UNITED STATES PATENT AND TRADEMARK OFFICE

APPLICATION NO.	FILING DATE	FIRST NAMED INVENTOR	ATTORNEY DOCKET NO.	CONFIRMATION NO.
10/802,890	03/17/2004	John K. Junkers	2839	4635
7590	06/07/2006		EXAMINER	
STRIKER, STRIKER & STENBY				MITCHELL, KATHERINE W
103 East Neck Road Huntington				
Huntington, NY 11743				
				ART UNIT
				PAPER NUMBER
				3677

Office Action Summary	Application No.	Applicant(s)
	10/802,890	JUNKERS, JOHN K.
	Examiner	Art Unit
	Katherine W. Mitchell	3677

DETAILED ACTION

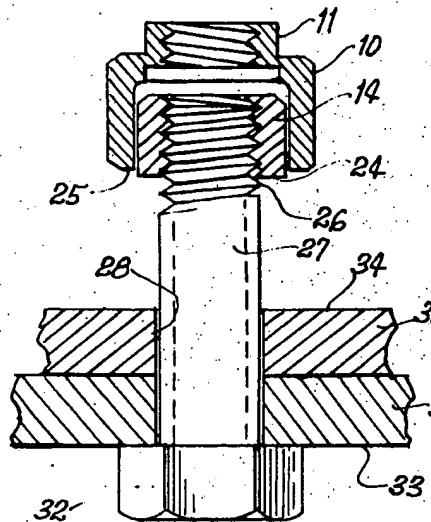
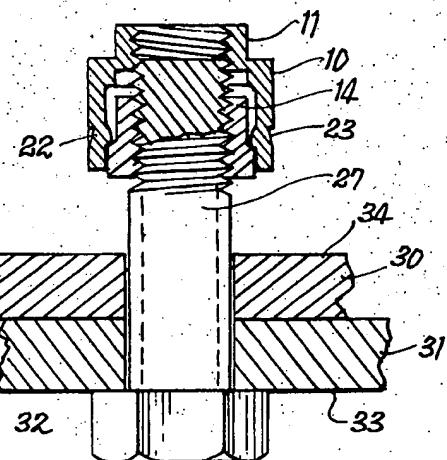
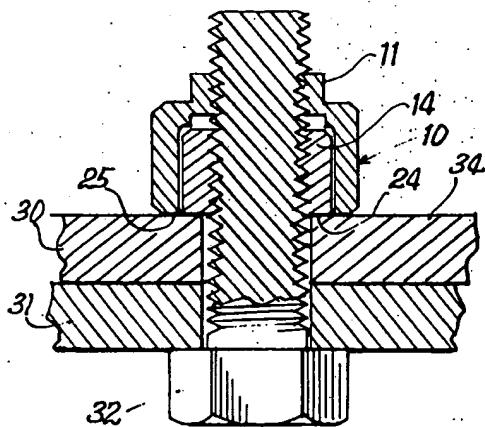
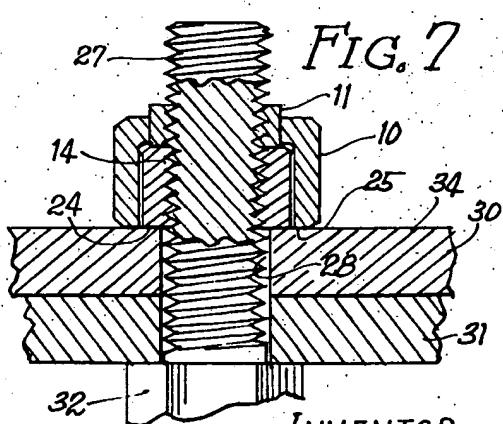
Grube teaches a washer with a body having an axis and first and second axial outer facial surfaces. Further, the washer has an additional turning resistant surface adapted to cooperate with a bolt, said additional turning resistant surface providing friction between the body and bolt to impede the bolt from turning and allowing the bolt to be axially displaced when the nut is turned (abstract Figs 4-7, col 3 line 59 - col 5 line 58). Grube Figs 4-7 teach the assembly of a washer in combination with the bolt.

Fig 4-7 show the turning resistant surface connectable with a bolt thread.

Fig. 4-7 show the body movable in the axial direction, and with one portion provided with said additional turning resistant surface and another portion frictionally connected to said one portion and provided with said second face surface which is adapted to frictionally cooperate with the object (at 24/25).

A breaking point is shown in Figs 6-7, which when broken when the bolt is turned, elongates the bolt in the axial direction.
